DESIGN CRITERIA AMENDMENTS

The Village at Mill Pond

HEARING EXAMINER REVIEW

APRIL 8, 2019

LOCATION | Associated Front and Side-Street Landscaping

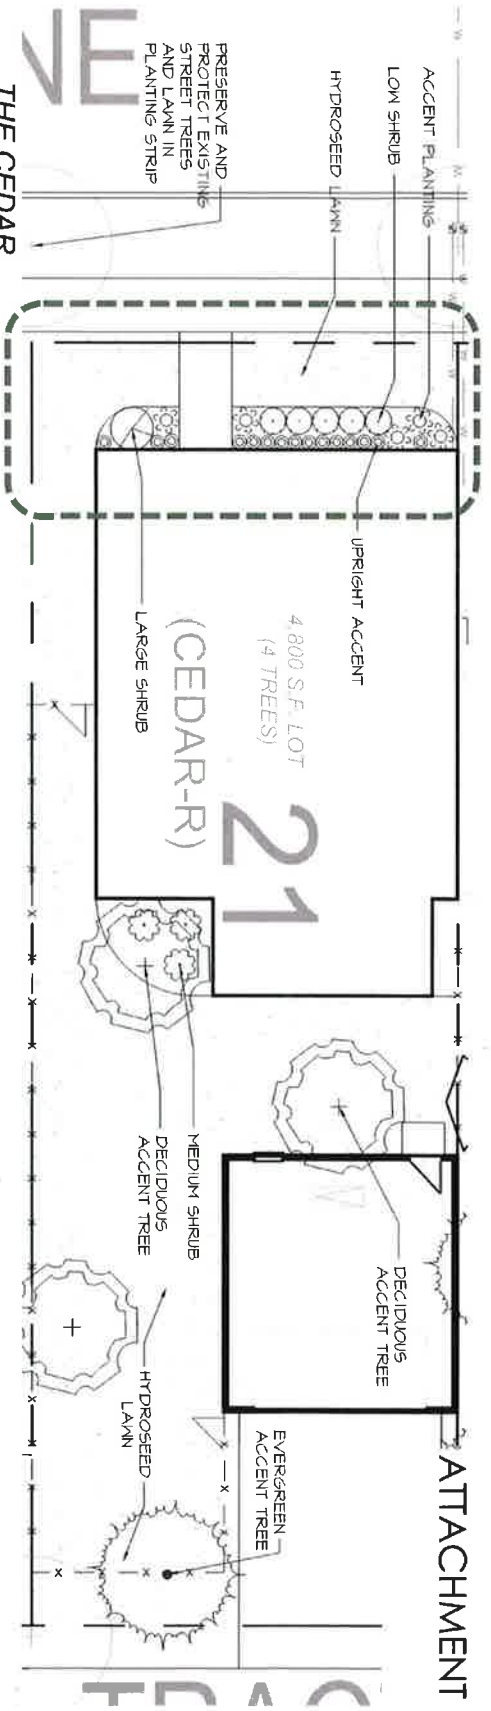
- Develop landscape in layers. ~~Low-street level and then~~ **Provide low landscaping near sidewalks**, foundation plantings at foundation, with and specimen trees as intermediate layer.

This amendment clarifies the location for plantings. The intent is not to require plantings to line the entire length of the street; it is simply a criteria for size of plantings at each specific zone around the lot.

Amendment removed for lack of clarity.

The current landscape plans approved by the City are already in compliance and there is no anticipated change to these designs.

NO LONGER PURSUING THIS AMENDMENT

LOCATION | Elevations and Models

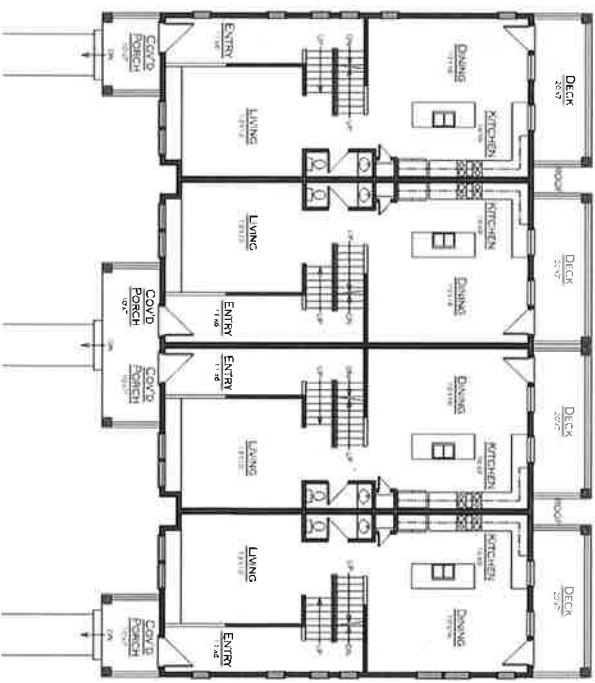
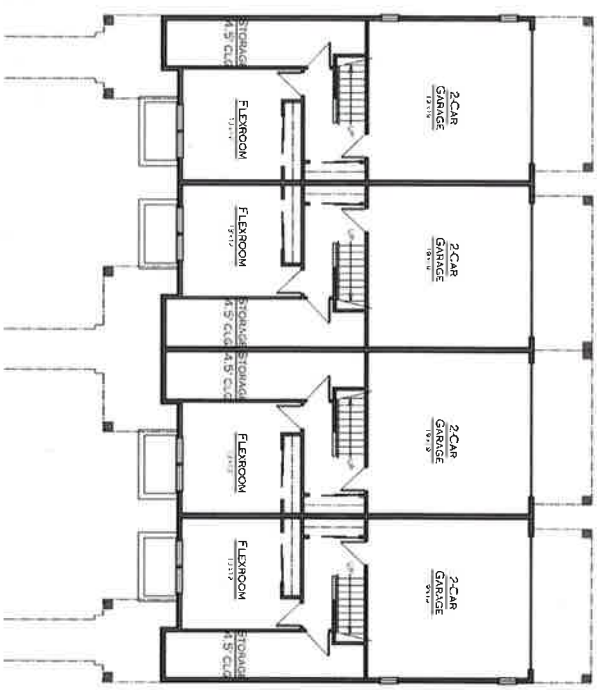
- Homes should have significant variations in the floor plans, which allows for variety in the massing of the home, with the exception that townhomes may have the same floor plan within each building.

This is a clarifying addition to the design criteria. Currently duplex, triplex & quadruplex style townhomes are part of the master plan development. Each unit within the townhome buildings will be repeated which allows for consistency in exterior appearance, economy in construction, and clarity in design. The goal of providing variety in buildings & units is maintained through compliance with other design guidelines for this development.

DRB APPROVES OF THIS AMENDMENT

LOCATION | Materials

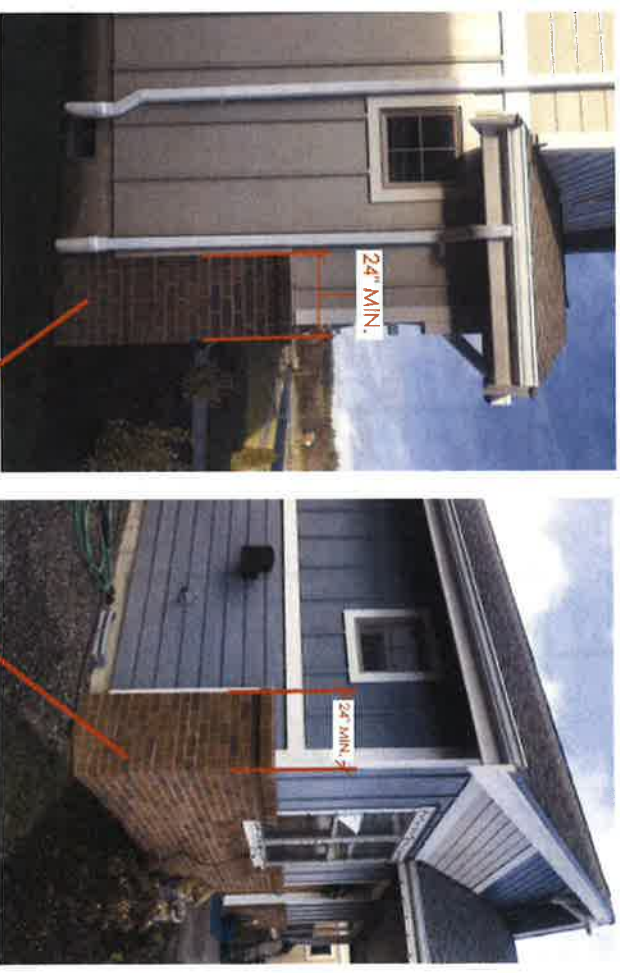
- Any vertical changes in materials in a vertical wall, such as from brick to wood, shall wrap the corners no less than 24 inches. The material change shall occur at an internal corner or a logical transition such as aligning with a window edge or chimney.

The term 'logical transition' is subjective and should be removed. The intent of providing nicer materials along the front façade while eliminating awkward outside corner transitions in materials would be achieved as long as materials return at least 24" along each side of the house.

DRB APPROVES OF THIS AMENDMENT

LOCATION | Architecture Details & Features

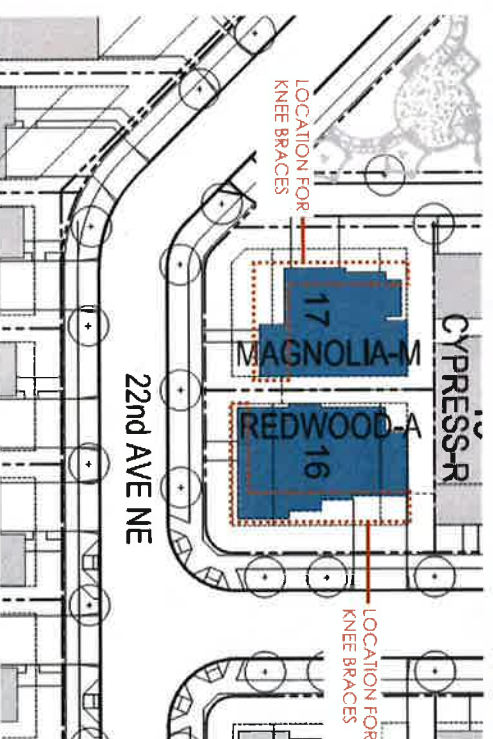
- At least two of the following features will be used at the front of the house and at each street facing or public open space facade: (a) Shutters, (b) Flower Boxes, (c) Knee Braces, (d) Columns

Clarifying extent of architectural detail does not extend to sides or back of house, which have little to no visibility from the street. This addition to the criteria still achieves the cohesive 'feel' of the development and meets the intent. Houses on corner lots or adjacent to public open spaces would still need to meet this requirement.

DRB APPROVES OF THIS AMENDMENT

LOCATION | Materials

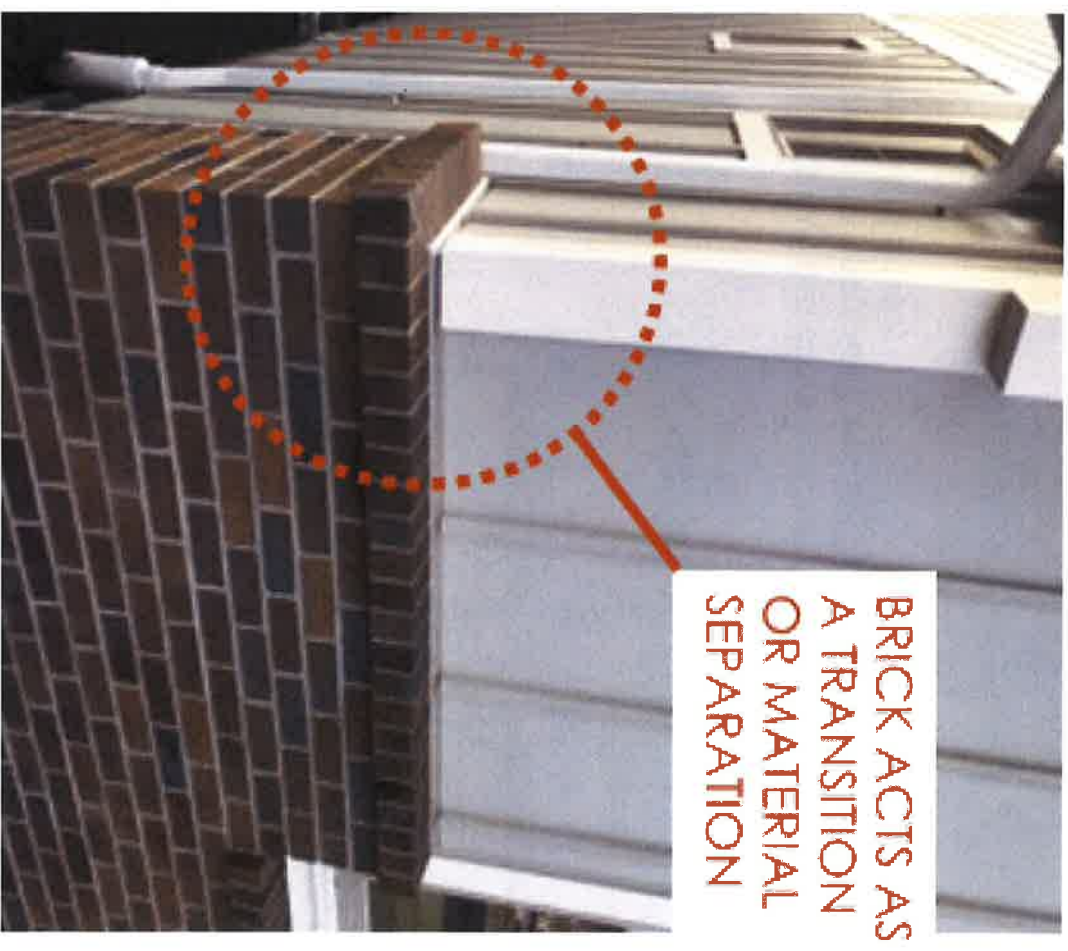
- Any horizontal transition in material on a wall surface, such as shingle to lap siding, shall have a material separation, such as trim band board. **Brick or cultured stone are considered a material separation. Trim band boards are not required at horizontal brick or stone transition.**

Brick and stone are materials that further enhance the appearance of the home; their nature and thickness allow them to act as a transition piece without the need for trim board. The 2-3 inches in material thickness provide a variety in depth and provide a break in the surface plane of the exterior elevation eliminating the need for a material change trim board.

DRB APPROVES OF THIS AMENDMENT

With added language requiring a ledge or cap on the brick or cultured stone to provide a transition

LOCATION | Entrances to Homes

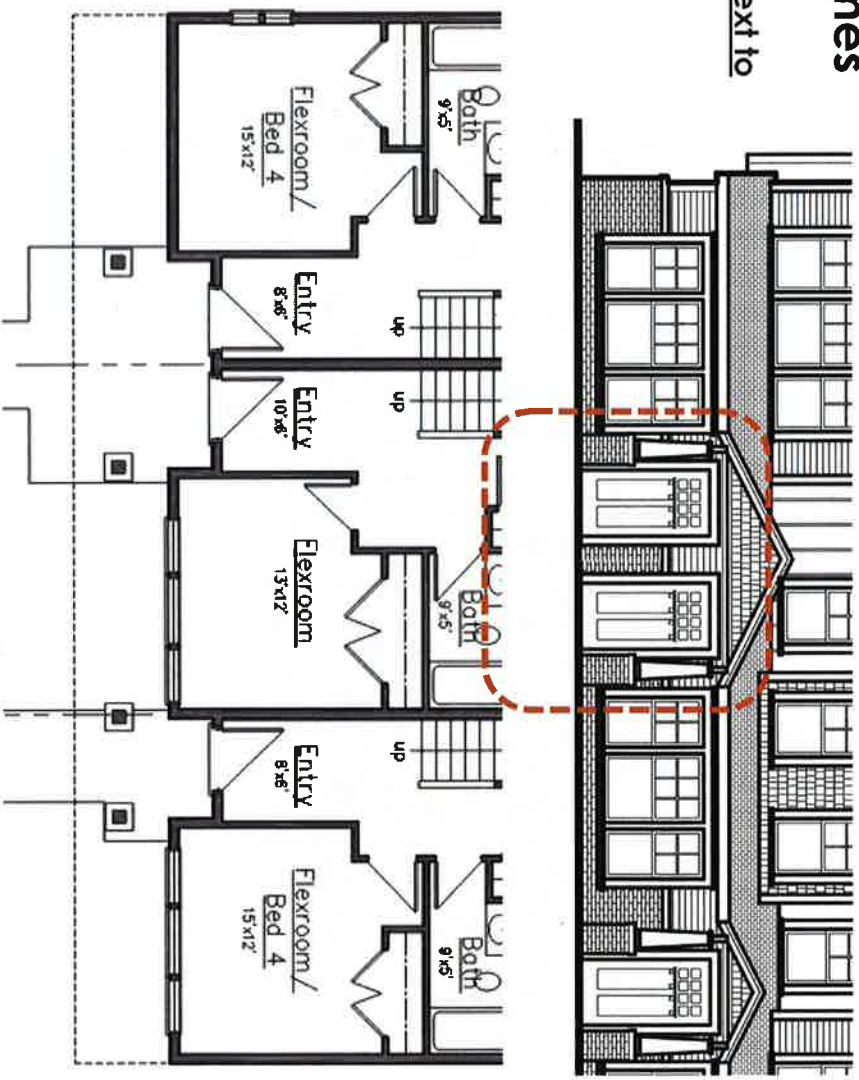
- Townhome entry doors may be located next to each other.

There is no minimum separation distance requirement between entry doors at townhomes. With 2-4 unit townhome style buildings, the need for entry doors to be located next to each other becomes imperative to maintain symmetry and balance in the elevations.

DRB APPROVES OF THIS AMENDMENT

With added language that doors must be offset or a divider between the doors such as a railing is provided to enhance a sense of privacy

LOCATION | Primary Windows

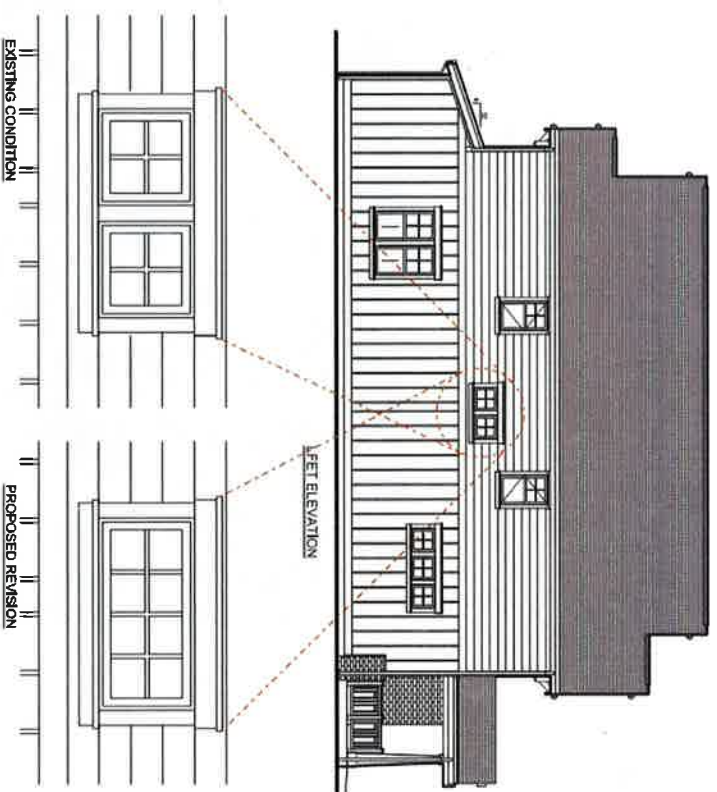
- Windows that are wider than tall are allowed when the following mullion divides and proportions are used which make the windows look taller than wide;
- A wide center vertical meeting stile in conjunction with:
 - A wide (2" minimum) horizontal muntin at the mid-point of the window to create an upper and lower portion, and;
 - Narrow grid divides in the upper portion.

This provides greater flexibility and still maintains the design intent of the above criteria.

DRB APPROVES OF THIS AMENDMENT

With added language that the proposed change applies to windows not facing a street or open space area

LOCATION | Primary Windows

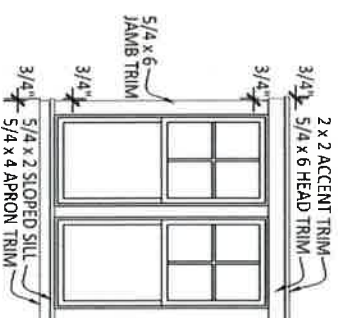
Windows shall have trim on all four sides. Trim must be appropriate to the architectural character. ~~Windows shall be either recessed or protruding (such as a bay window).~~ Windows not facing the front or street may be 'picture framed' with same size trim piece around all four sides.

Removal of unclear sentence. This implies all models to get bay window. Windows will be trimmed out on all four sides and installed in plane with wall.
See attachment 12-A Window Trim for example of how this criteria is addressed in existing site.

DRB APPROVES OF THIS AMENDMENT

As modified by the board to retain the portion of the sentence: "Windows shall be either recessed or protruding." Remove "(such as bay windows)" from the sentence.

LOCATION | Elevations and Models

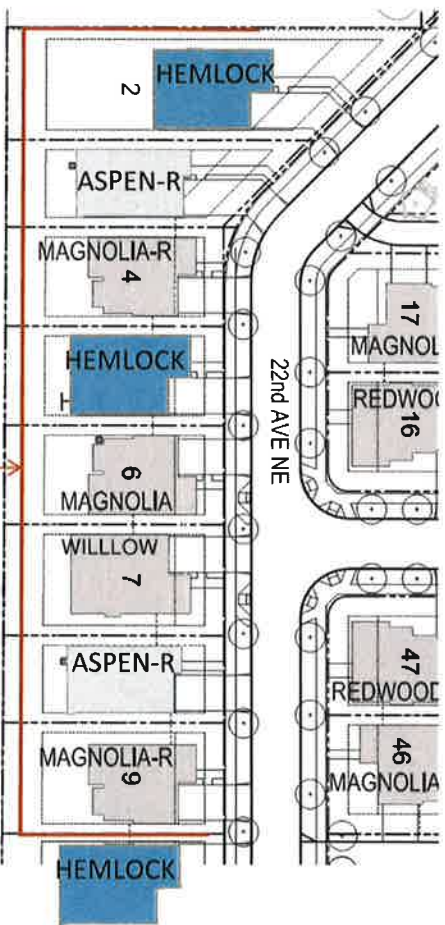
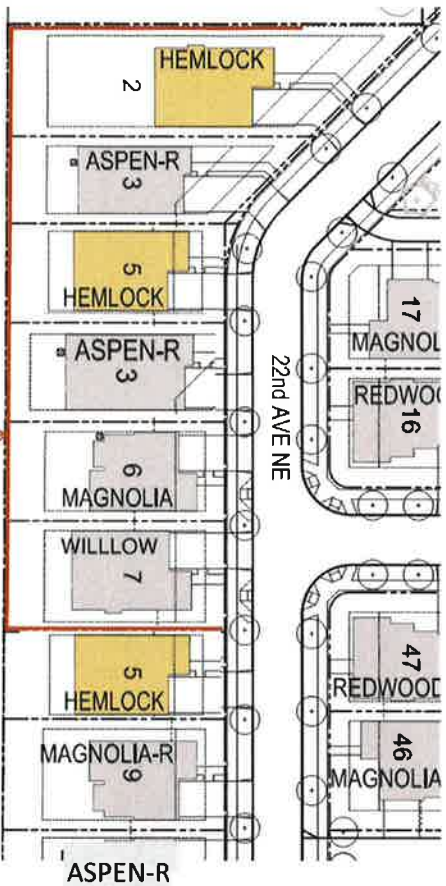
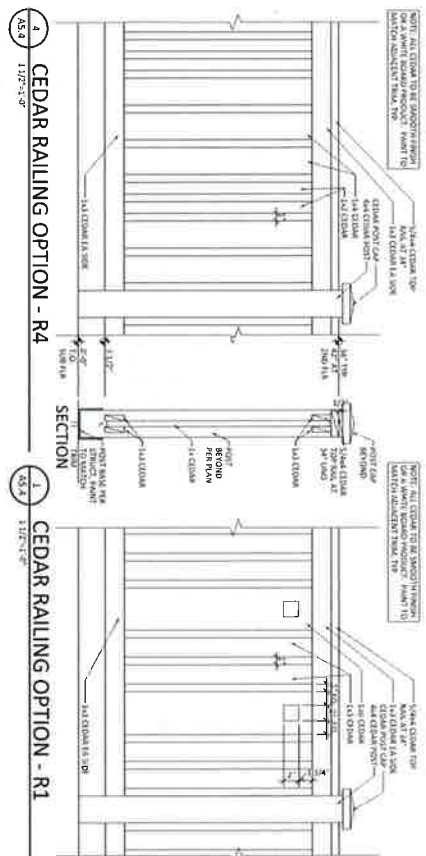
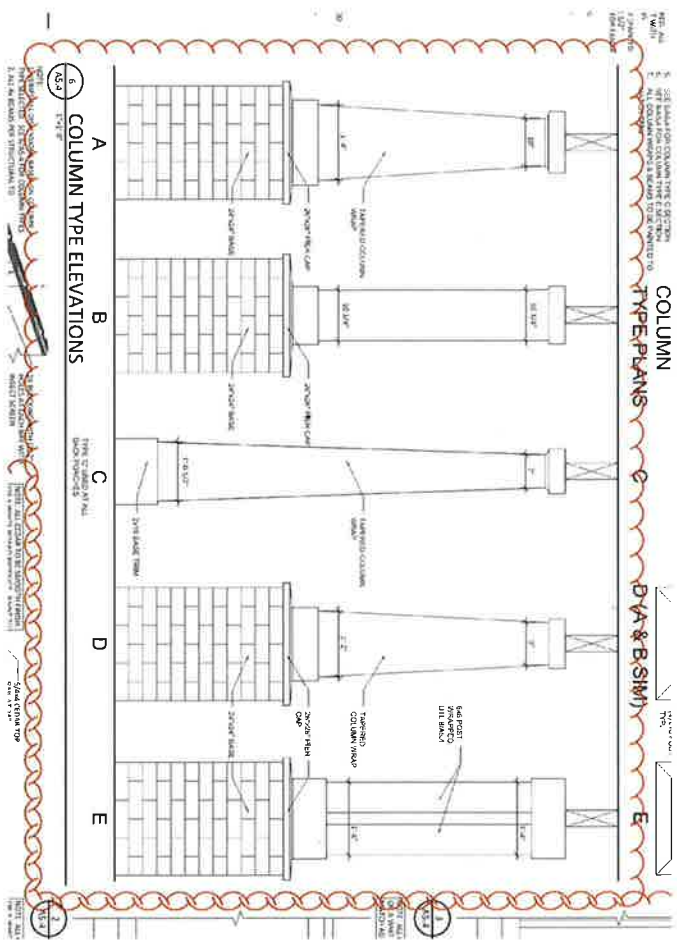
EXISTING DESIGN CRITERIA
NO MORE THAN 2 MODEL PER 8 CONTINUOUS LOTS
MODEL: ASPEN

PROPOSED DESIGN CRITERIA
NO MORE THAN 2 MODEL PER 6 CONTINUOUS LOTS
MODEL: HEMLOCK

No more than two of the same model and elevation will be built **within six continuous lots**, within eight contiguous lots.

There are currently **18** different single-family model options to choose from at the Village at Mill Pond. The current 2 per 8 contiguous lot requirements does not provide for flexibility in market demand. Inevitably, there are certain models that are more popular among prospective home buyers. Revising the contiguous requirement from 8 to 6 would create more options for development and accommodate pre-selling lots with a desired model type that is contrary to the original layout.

DRB DOES NOT APPROVE OF THIS AMENDMENT
